**NRDC Comments on 40 CFR 192, Health and
Environmental Protection Standards for Uranium and
Thorium Mill Tailings, Proposed Rule, 80 Fed. Reg.
4156-4187 (Jan. 26, 2015), Docket ID No. EPA-HQ-
OAR-2012-0788.**

May 27, 2015

RE: Docket ID No. EPA-HQ- OAR-2012-0788, *Natural Resources Defense Council Comments on 40 CFR 192, Health and Environmental Protection Standards for Uranium and Thorium Mill Tailings, Proposed Rule.*

FIGURE 1:

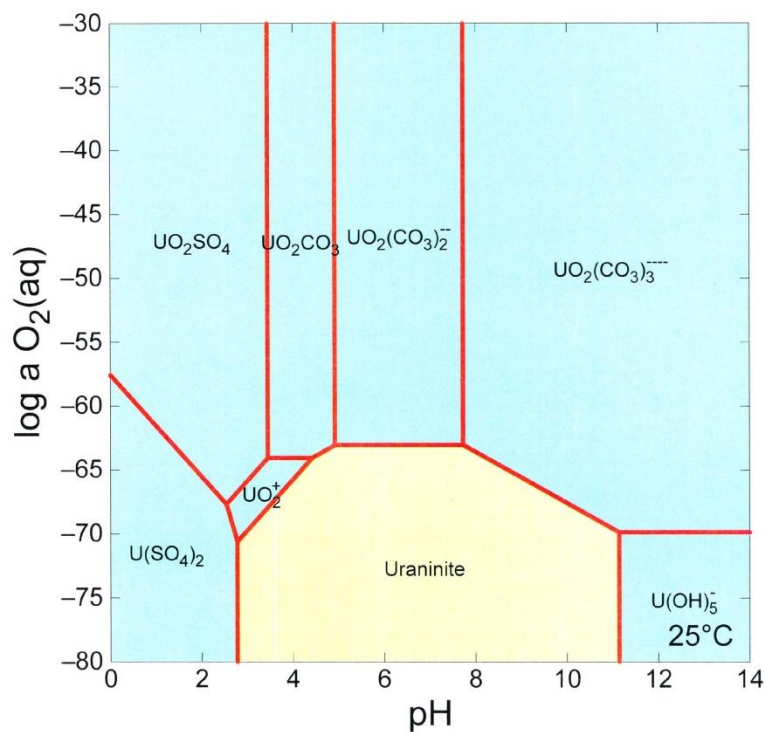
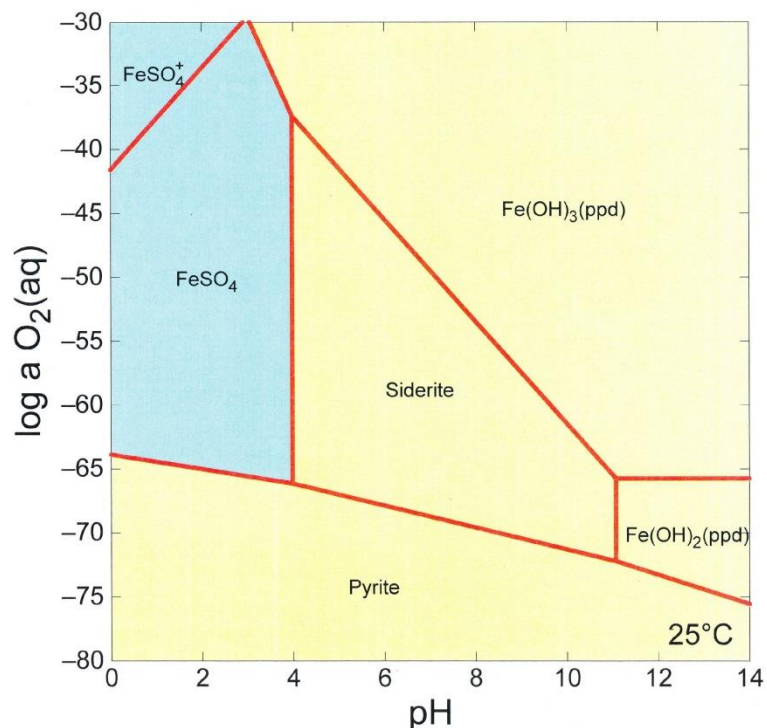
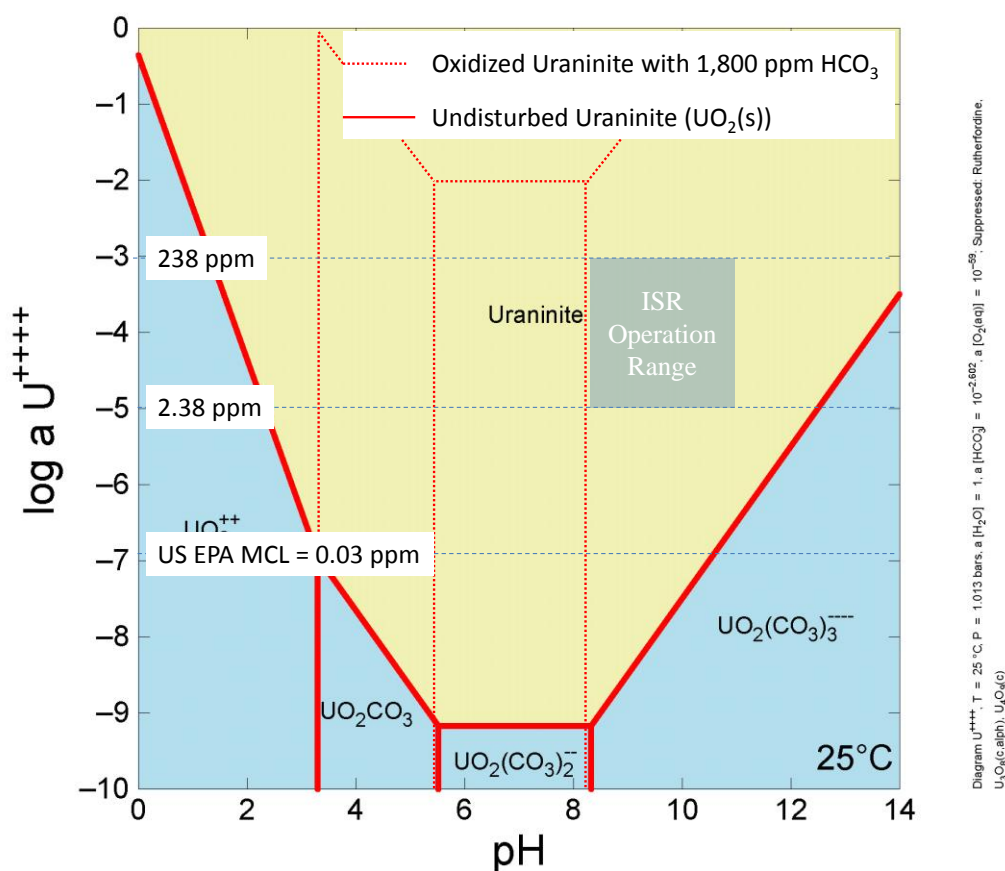
Below are Pourbaix diagrams displaying relevant geochemical conditions from Geochemist Workbench®. The top figure shows Iron and bottom figure shows the uranium stability fields.

The addition of a lixiviant and complexing agent to a reduced uranium ore creates a violent oxidation process which significantly alters the geochemistry and hence the solubility of uraninite in solution. These two conditions are signifying the incredible change in chemistry due to addition of lixiviant. The figure below, first produced today for these comments, demonstrates the theoretical change in uraninite solubility when no oxygen is present (solid red line) and when oxygen and carbonate is added to the model (dashed red line). The gray region approximates the geochemical conditions present when ore is extracted from the production zone. This significant change in geochemistry should make it apparent to EPA that there are substantial differences between pre-mining, original conditions and post-restoration conditions that have much less to do with the natural mineralized state of the water.

FIGURE 2

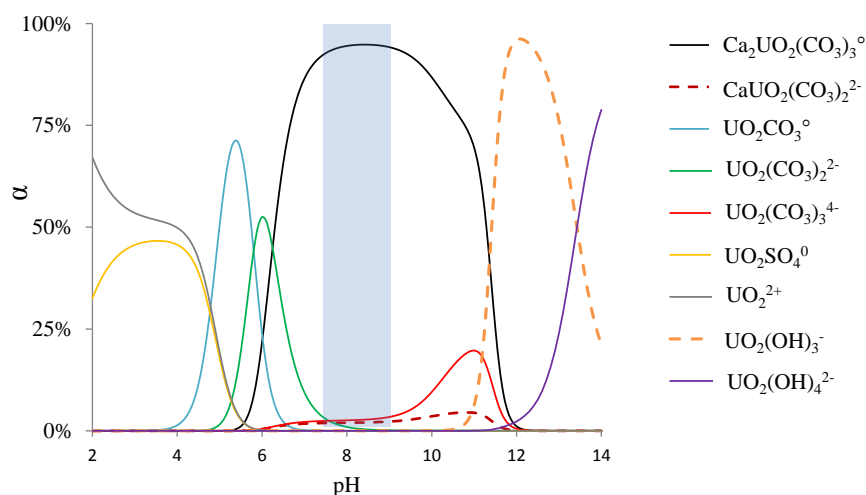
We've created the figure below using a geochemical modeling software (PHREEQC v.3.1.2) using an updated thermodynamic database which includes the formation of the $\text{Ca-UO}_2\text{-CO}_3$ complexes and representative average stability data from Christensen Ranch ISL mine unit 5. The pH was the master independent variable and average post-restoration constituent concentrations were held constant. The shaded grey region shows the range of measured pH values from the stability samples at Christensen Ranch. The table below the figure shows the input data into the thermodynamic database and model. This figure shows, unequivocally, that the representative geochemical conditions in the aquifer post-restoration are largely dominated by $\text{Ca-UO}_2\text{-CO}_3$ complexes predicted by the updated thermodynamic database. This evidence demonstrates that NRC and industry are using outdated assumptions about uranium geochemistry and transport, and EPA should, at a minimum, incorporate the updated science into its reasons for the rule. .

FIGURE 3: THEORETICAL REACTIVE TRANSPORT MODEL FROM AN ISR SITE DISPLAYING THE

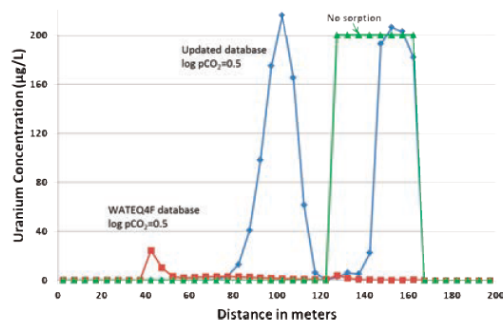
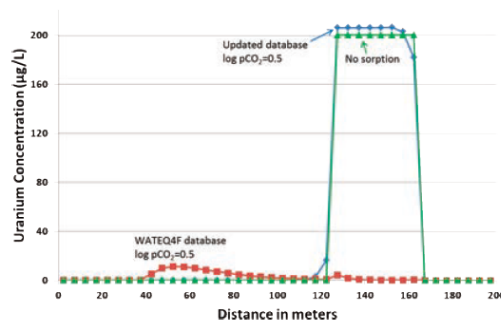
These older models are problematic for accurately predicting the rate at which uranium moves through the groundwater. According to the USGS and the geochemical conditions modeled, within 25 years the front edge of the uranium plume was predicted to migrate roughly 165 m (See figure above). More importantly is the vast difference between model results for the updated thermodynamic database (Blue) and the outdated thermodynamic database (Red) suggesting that uranium transport from ISR sites is grossly underestimated and transport of high levels of uranium concentrations beyond the well field could reasonably occur within the span of a human life time or a matter of decades once hydraulic control is lost or absent.

FIGURE 4: A) COMPARISON OF BASELINE AND STABILITY MONITORING FOR CHRISTENSEN RANCH MINE UNITS 2-6 AND B) CUMULATIVE HISTOGRAM OF GROUNDWATER URANIUM CONCENTRATIONS

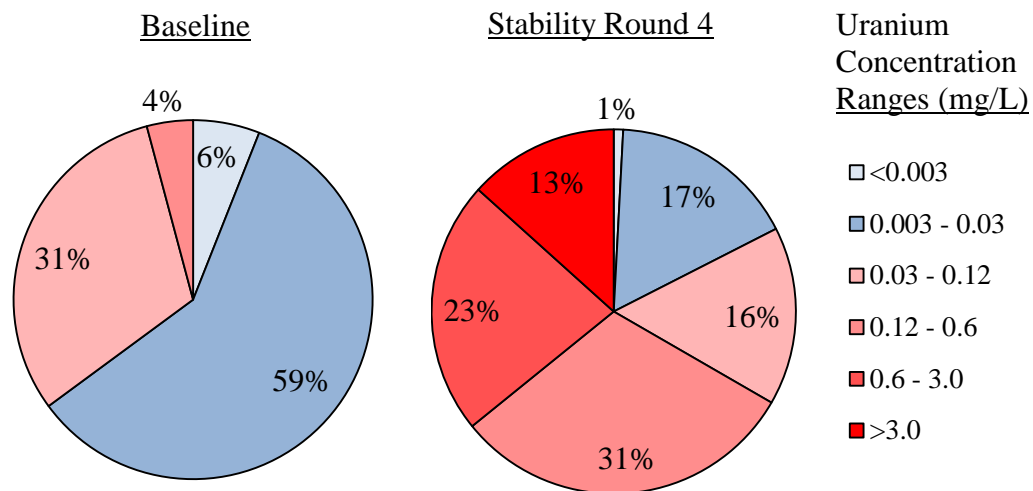
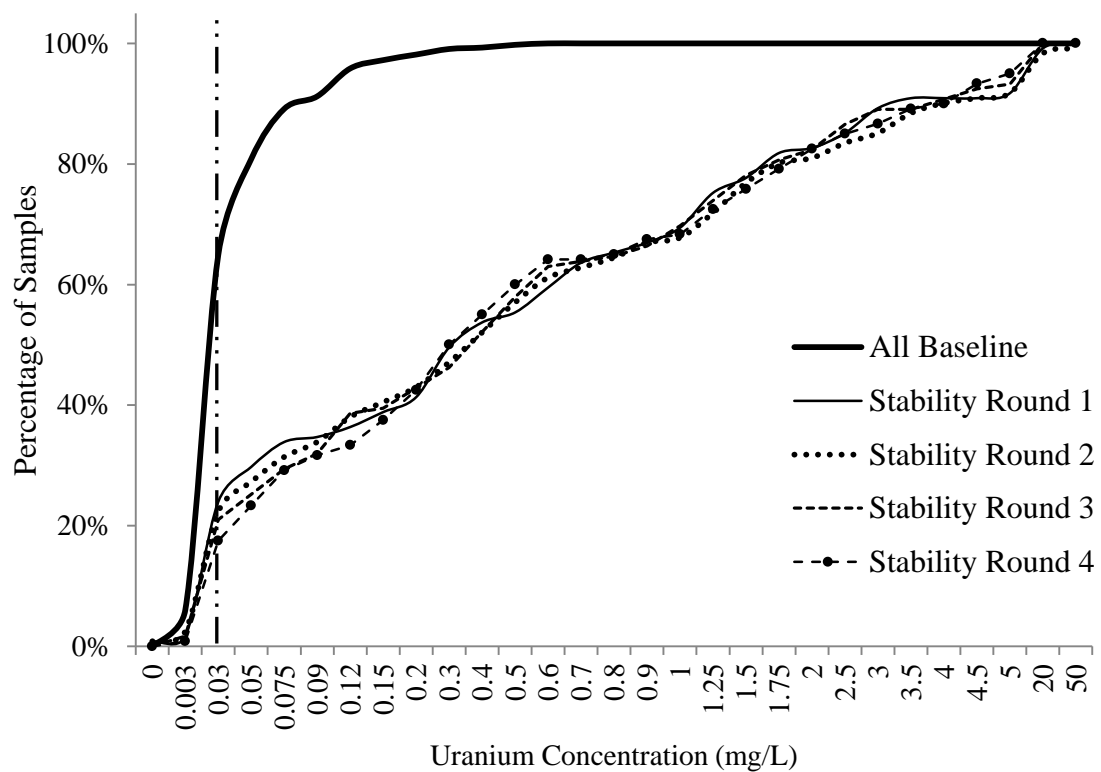
We provided a cumulative histogram for groundwater data from the Christensen Ranch ISL site (Figure 4; Comment #57). The results demonstrate that approximately 65% of all baseline samples (n = 433) were <0.03 mg/L, 31% were between 0.03 – 0.12 mg/L, and 4% were between 0.12 - 0.60 mg/L (Figure 4A). After ISL and groundwater operations at Christensen Ranch, the groundwater quality distribution observed substantially elevated uranium concentrations. Post-Restoration stability sampling round 4 results observed approximately 18% of the groundwater sample were <0.03 mg/L, 47% between 0.03-0.60 mg/L, and two new categories of elevated uranium concentrations were observed which

observed 23% of samples were 0.6 - 3.0 mg/L, and 13% were >3.0 mg/L (Figure 4A).

Examining the groundwater quality distribution cumulatively for each post-restoration round circumvents issues with sporadic data trends for a given well (Figure 4B). The data suggests that the groundwater quality distribution across all mine unit samples display little appreciable temporal changes. If natural attenuation mechanisms were substantially decreasing the net uranium mass in groundwater, the post-restoration data distribution trends would progressively trend back to the baseline distribution. However, there's little difference between round 1-4 stability sampling distributions, suggesting the net groundwater uranium mass is staying relatively constant throughout the stability sampling period.

FIGURE 6

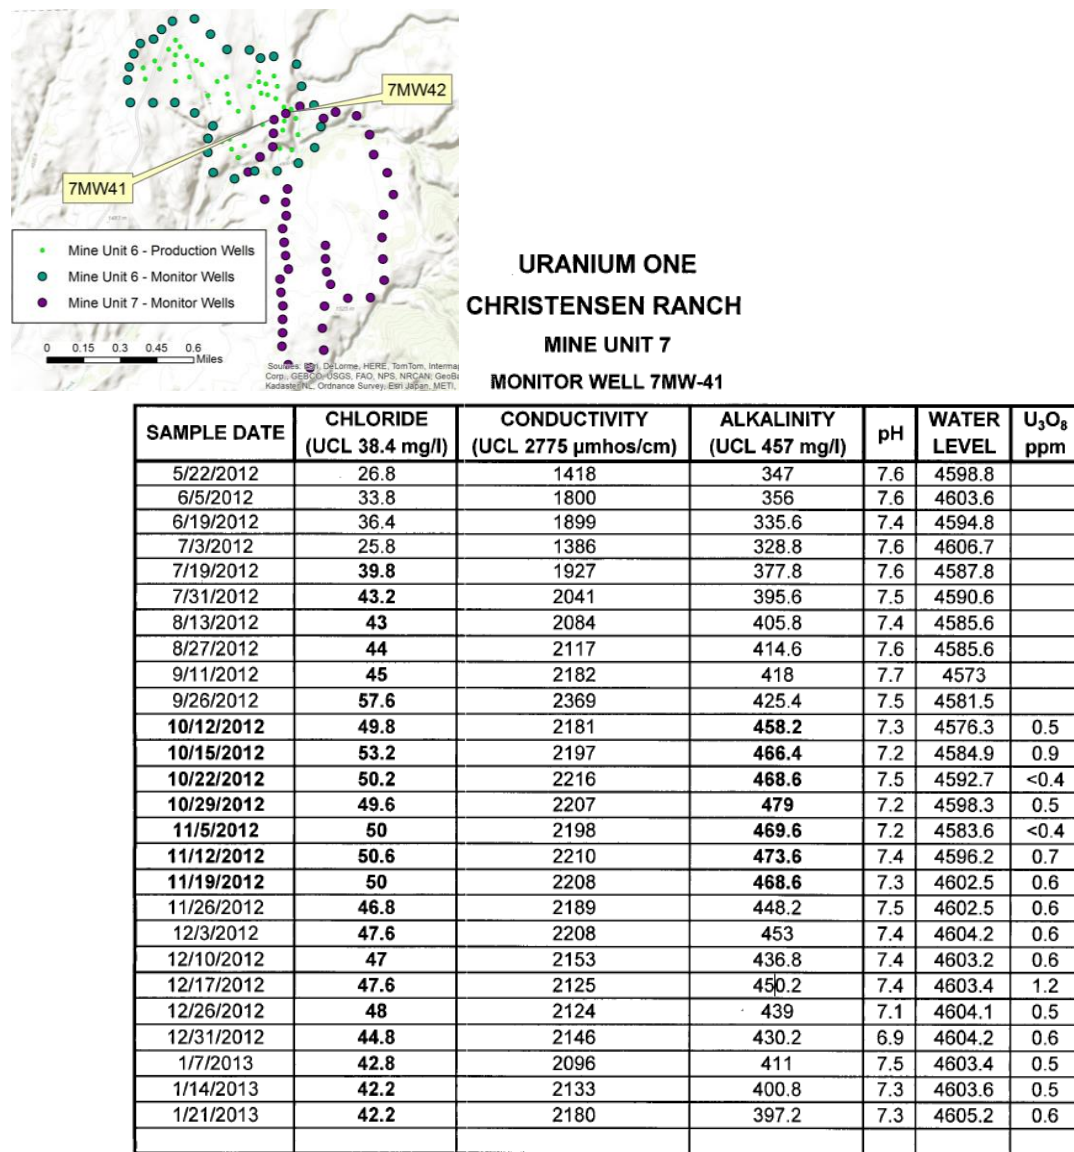
Further, the current use of UCLs masks potential impacts to surrounding and adjacent aquifers. As one example from the Willow Creek ISL site, baseline water quality samples were taken from well 7MW41 between 10/28/1997 and 12/4/1998.¹²⁵ Average concentrations of chloride, conductivity (reported as electrical conductivity or EC), alkalinity, and uranium were as follows, respectively: 7.2 mg/L, 855.5 umho/cm, 91.7 mg/L as CaCO₃, and 0.0004 mg/L.

The table was taken from when the excursion report specifically for well 7MW41 (ML13037A321) and the inset map shows the location of 7MW41 located within the production zone of MU6 and the spatial overlap of monitoring wells into production zones. Note that mine unit 6 had applied for restoration approval by the NRC but was denied (JT1035).

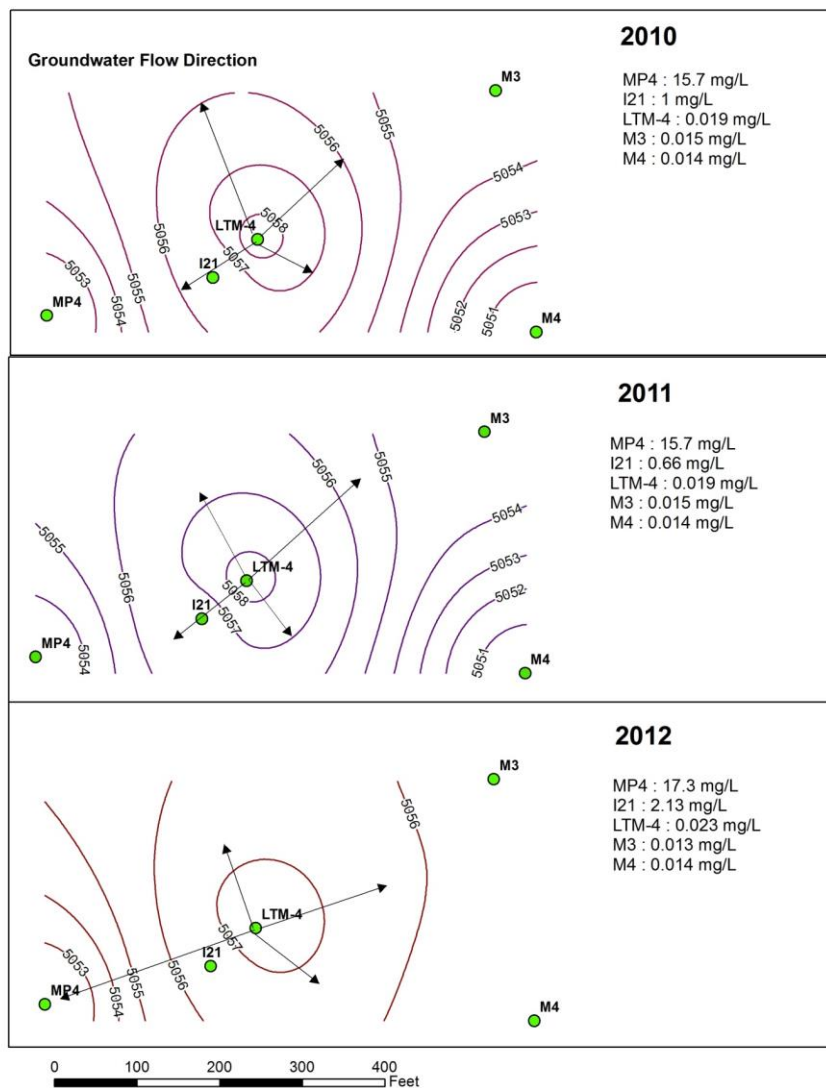
However, the 'water level' data¹⁴² suggest that the groundwater flow direction was moving away from LTM-4, not towards it (Figure 8). According to hydrogeology, groundwater flows from high to low potentiometric surface.

With this information regarding the science and history of fluid excursions, EPA's rule must require all ISL sampling, throughout all stages of operations, to include proper sampling methods, quality control, and sample documentation before it accepts *any* groundwater samples. Furthermore, these analytical sampling techniques *must be required* in accordance with EPA guidelines) or scientific based Standard Methods). The use and reliance of an unknown, inconsistent, and inadequate analytical technique does not support a scientifically defensible excursion monitoring program and calls in to question much of the assumptions of 'slow', 'lock-in', or 'naturally attenuated' uranium transport behavior. In other words, if uranium is not detected, above an extremely high detection limit, then industry and regulators will be able to assume that it is lagging behind the lixiviant plume. This is not consistent with the empirical data, nor the current understanding of the non-reactivity of Calcium-uranyl-carbonate complexes.
